RE: Hammond River Holdings' Response to Technical Review Committee (TRC)
Questions and Comments Round #3 – Proposed Upham East Gypsum Quarry, EIA
Registration Document File No. 4561-3-1508

HAMMOND RIVER HOLDINGS LIMITED
PROPOSED UPHAM EAST GYPSUM QUARRY

CONCEPTUAL SITE LAYOUT PLAN
FIGURE 2.3.1

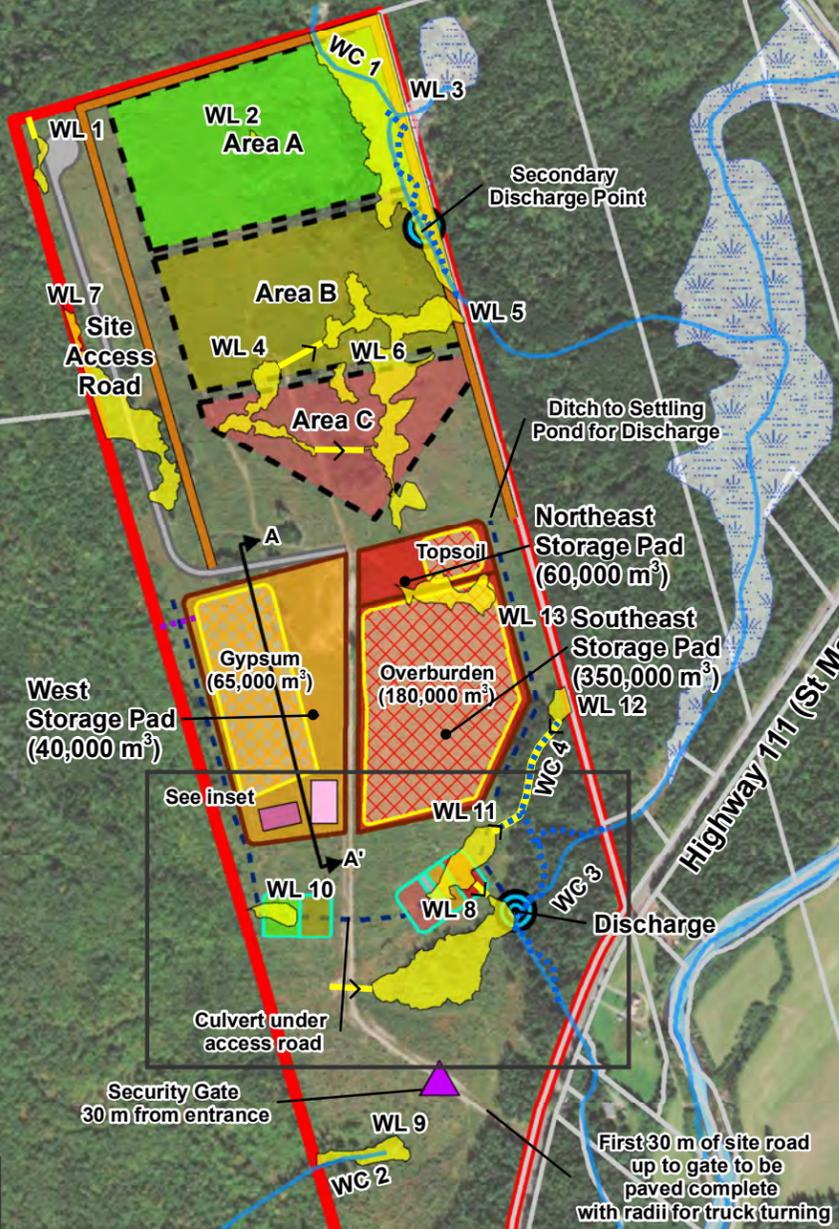
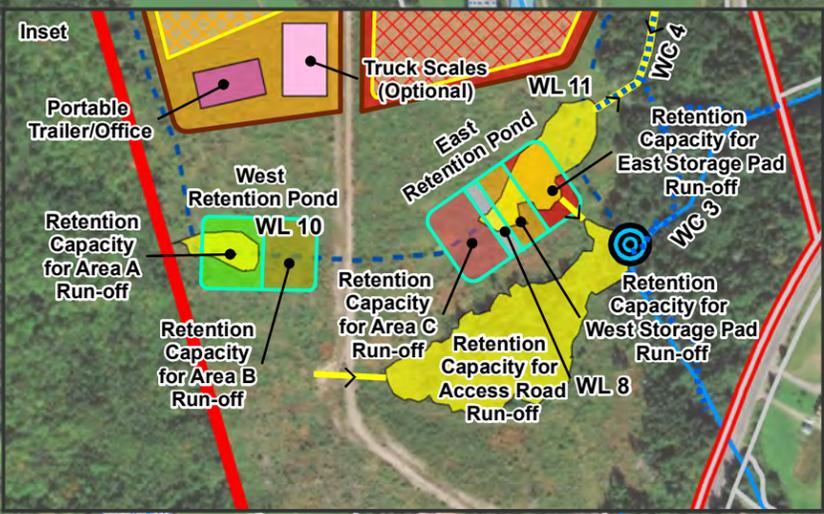
"23. Although the responses provided indicate that a compensation plan for the loss of regulated wetlands will be developed, can you please, at this time, propose mitigative actions, based on the results of the functional assessment, for the unmapped wetlands that will be lost as a result of the project?"

- conceptual site layout plan that has evolved since the preparation of the EIA registration document is attached. For ease of review by the TRC, we have overlaid the wetland layer for mapped and field-identified wetlands and watercourses on this updated site layout plan.

- In addition to the pit sump at the bottom of the quarry, two retention (settling) ponds have been added to the design: the West retention pond (receiving runoff from Areas A and B of the quarry), and the East retention pond (receiving runoff from Area C of the quarry as well as from the access road and the West, Northeast, and Southeast storage pads). The retention ponds have been repositioned and subdivided into two sub areas to improve alignment with a topographic low on the property. The West retention pond will discharge into the East retention pond, providing additional retention capacity, with both retention ponds discharging to a common location into watercourse WC3. It is noted that the pit sump will now discharge to the retention ponds instead of being pumped directly into watercourse WC1.

- The orientation of the retention ponds has been optimized based on runoff calculations for the refined quarry footprint, storage pad areas, and LiDAR data.
